SUBJECT: Cessation of Train Whistle – King Street Railway Crossing, Dartmouth

Re : Grade Crossing Safety Assessment :
King St,
Dartmouth Sub - Mile 12.99

Table 1: Observations / Suggestions

M.12.99- King St. Sketch

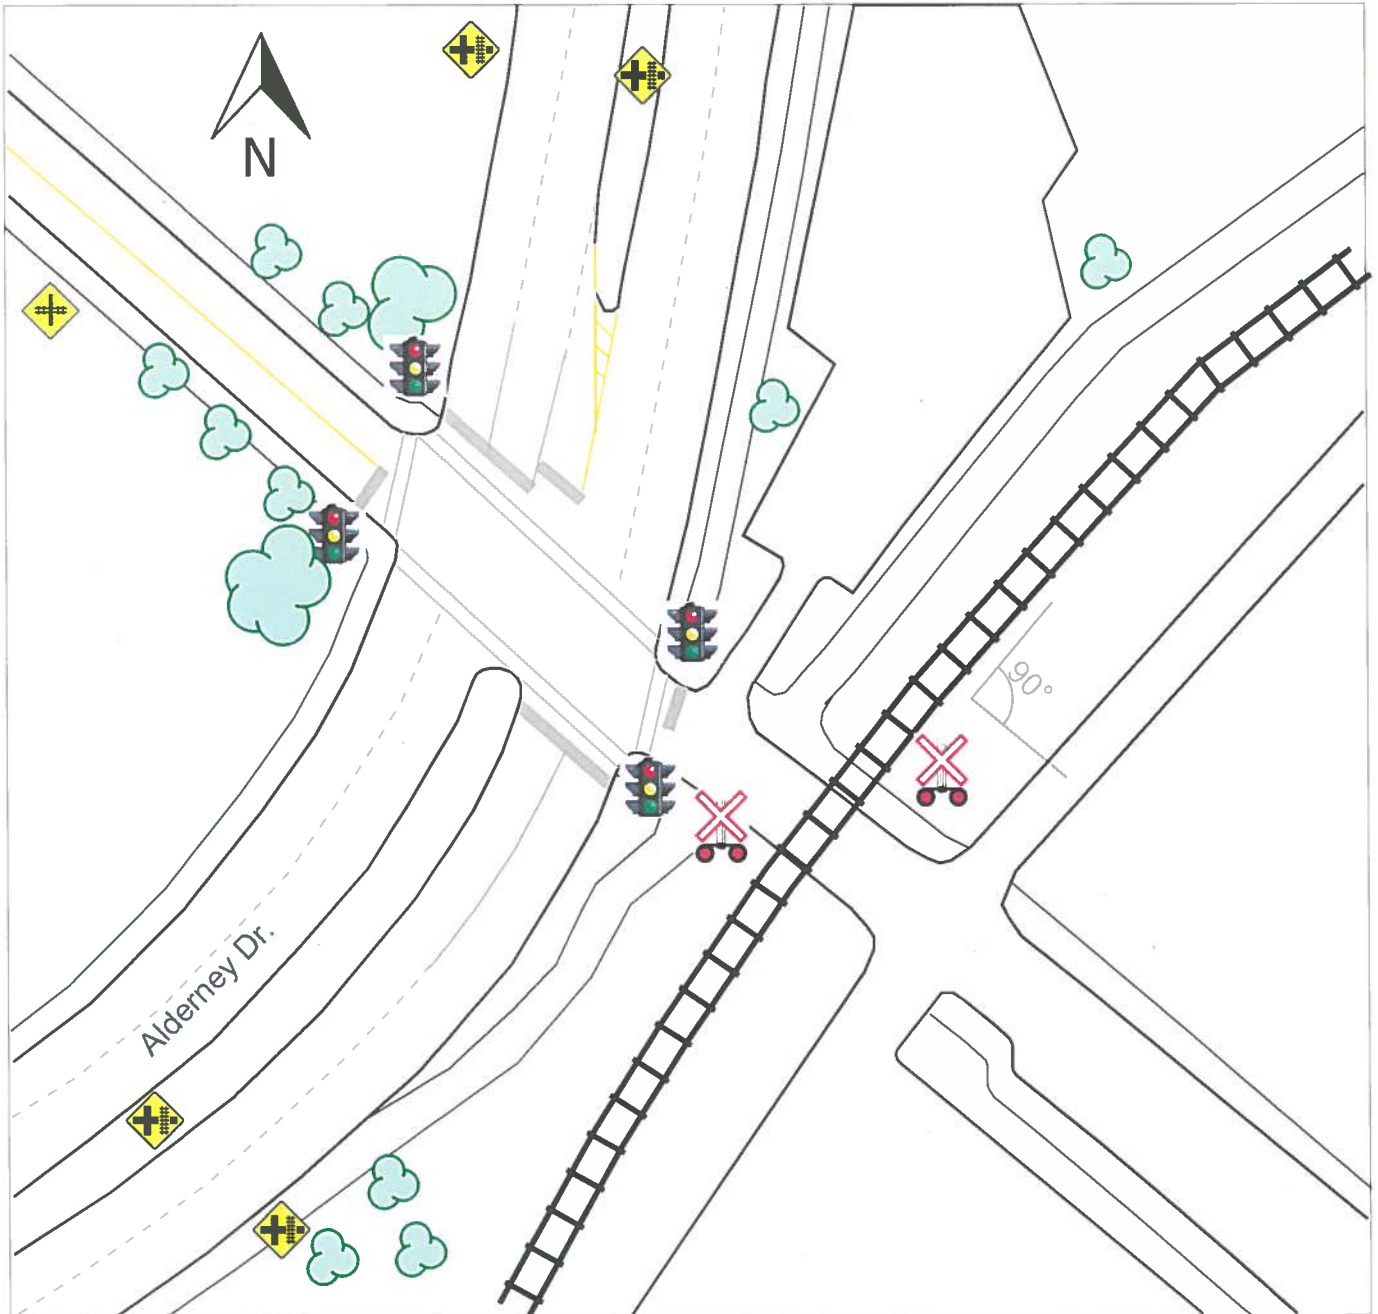
Observations		Suggested Actions	To	Client Response	
1	NW quadrant -Crossing sign hidden by lights (see photo 9).	Adjust position of crossing sign and lights	Railway		Comments
2	NW Quadrant - Evidence of routine unauthorized access (trespassing) on the rail line (see photo 11)	Sidewalk is needed as well as fencing to prevent trespassing.	Railway/Road authority		
3	NW Quadrant - Advanced warning sign is not at the appropriate distance from the North side.	Reposition WA-18 sign on King St. 110m from crossing.	Road authority		
4	NW Quadrant – Potential Traffic queuing onto intersecting roadway from crossing	No right turn on red signal needed for right turn from Alderney Drive to King Street towards crossing.	Road authority		
5	NW/NE Quadrant - crossing sign obscured by trees (see photo 8)	Trim or remove trees to improve visibility of crossing signs	Road authority		
6	NE Quadrant – Sidewalk not protected by gates and lights	Pedestrian gates and lights are needed for sidewalk on the NE side of crossing.	Railway

7	SE Quadrant - Advanced warning sign is not at the appropriate distance from the crossing.	Add WA-18 signs on King St. 110m from crossing.	Road authority		
8	SE Quadrant - Pavement markings are missing.	All required pavement markings should be applied: “X” marking, “No Passing” lines, and “Stop” bars.	Road authority		
9	SE Quadrant – Traffic queuing onto crossing from intersection	Do not stop on track sign needed for South approach.	Road authority

10	SW Quadrant – partial sidewalk/pathway not protected by gates and lights.	Pedestrian gates and lights are needed. Sidewalk should be completed on the SW side of crossing.	Road authority		
11	Crossing surface – Elevation of top rail is 40mm below crossing surface.	Crossing surface should be adjusted to be less than 25mm above the top of rail.	Railway/Road authority		
12	Gate descent time was measured at 7 seconds and gate arm delay was measured at 6 seconds	Gate descent time should be adjusted to be within 10 to 15 seconds and gate arm delay should be adjusted to 7 seconds.	Railway		
13	Parking lots on both sides of the road in the south approach to the crossing do not have light unit coverage (see photos 12 and 13)	Additional light units are required for drivers as they begin to turn onto the approach road from the two parking lots.	Railway/Road authority

Requirement (received Feb 28 ^{/15} from Hatch Mott and Macdonald).		Suggested Action	Responsibility	Status/Next Steps
1.	NW quadrant – Crossing Sign hidden by lights.	Adjust position of crossing sign and lights	CN Rail	CN to adjust / relocate sign.

2.	NW Quadrant – Evidence of routine unauthorized access (trespassing) on the rail line	Sidewalk is needed as well as fencing to prevent trespassing	CN Rail / Kings Wharf	Dexter Construction to complete as part of original contract.

3.	NW Quadrant- Advanced warning sign is not at the appropriate distance from the North Side.	Reposition WA-18 sign on King St. 110m from crossing	HRM	Signage location was reviewed and determined that current placement is appropriate. CN agreed.

4.	NW Quadrant – Potential Traffic queuing onto intersecting roadway from crossing.	No right turn on red sign needed for right turn from Alderney Drive to King Street towards crossing.	HRM	HRM is currently in discussions with Transport Canada to determine appropriate operation of traffic signal / grade crossing warning system interconnect as per the Grade Crossing Standards. This item is still outstanding, but is in progress.

5.	NW/NE Quadrant – crossing sign obscured by trees.	Trim or remove trees to improve visibility of crossing signs.	HRM	HRM Urban Forestry was tasked with evaluating the situation and trim trees as appropriate.

6.	NE Quadrant – Sidewalk not protected by gates and lights.	Pedestrian gates and lights are needed for sidewalk on the NE side of crossing.	CN Rail	CN Rail has determined this to be unnecessary.

7.	SE Quadrant – Advanced warning sign is not at the appropriate distance from the crossing.	Add WA-18 signs on King's Wharf Place 110m from the crossing.	HRM	An appropriate location has been identified for this roadway approach and signage will be installed. CN in agreement.

8.	SE Quadrant – Pavement markings are missing.	All required pavement markings should be applied 'X' marking. "No Passing" lines and stop bars.	HRM	HRM to install double stop bars at the grade crossing. "X" markings are not required. CN is in agreement with this approach.

9.	SE Quadrant – Traffic queuing onto crossing from intersection.	Do not stop on track sign needed for South approach.	HRM	HRM to install "Do not stop on track" sign, but cross-hatching will not be required.

10.	SW Quadrant – partial sidewalk/pathway not protected by gates and lights.	Pedestrian gates and lights are needed. Sidewalk should be completed on the side of crossing.	HRM	CN Rail has determined this to be unnecessary.

11.	Crossing surface – Elevation of top rail is 40mm below crossing surface	Crossing surface should be adjusted to be less than 25mm above the top of rail.	CN Rail / HRM	Crossing surface to be reviewed at next scheduled maintenance and rehab date. Not required to request whistle cessation.

12.	Gate descent time was measured at 7 seconds and gate arm delay was measured at 6 seconds.	Gate decent time should be adjusted to be within 10 to 15 seconds and gate arm delay should be adjusted to 7 seconds.	CN Rail	CN has indicated that the equipment at the location is working properly and is in compliance with requirements.

13.	Parking lots on both sides of the road in the south approach to the crossing do not have light unit coverage	Additional light unit are required for drivers as they begin to turn onto the approach road from the two parking lots.	CN Rail / Kings Wharf	CN has determined that additional lights are required. They have provided a cost to have the lights supplied / installed and are requesting payment before scheduling the work.

14.	Access to Parking Garage during train crossing may be blocked causing queuing on tracks. (added by CN Rail)	Requires "hatching: in front of access to parking garage to prevent cars from blocking entry.	HRM	HRM will install additional signage related to blocking of the driveway as well as additional "Do not stop on tracks" signage. Painted hatching will not required.
